Submitted by the expert from FIA

FIA position on

**Lifecycle** of a vehicle type\* vs. **Lifetime** of a vehicle

Lifecycle of a vehicle type\*

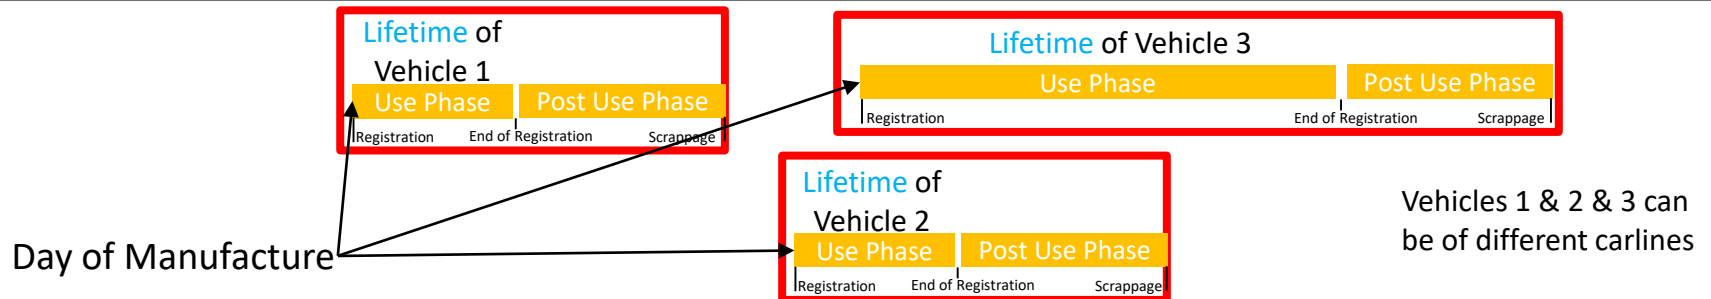
## FIA likes to amend:

- “**lifecycle**” is longer than all vehicle lifetimes and lasts at least until scrappage
- **IT security support must not end at the end of production**
- **Post Production regulation is covered by the 58 agreement**
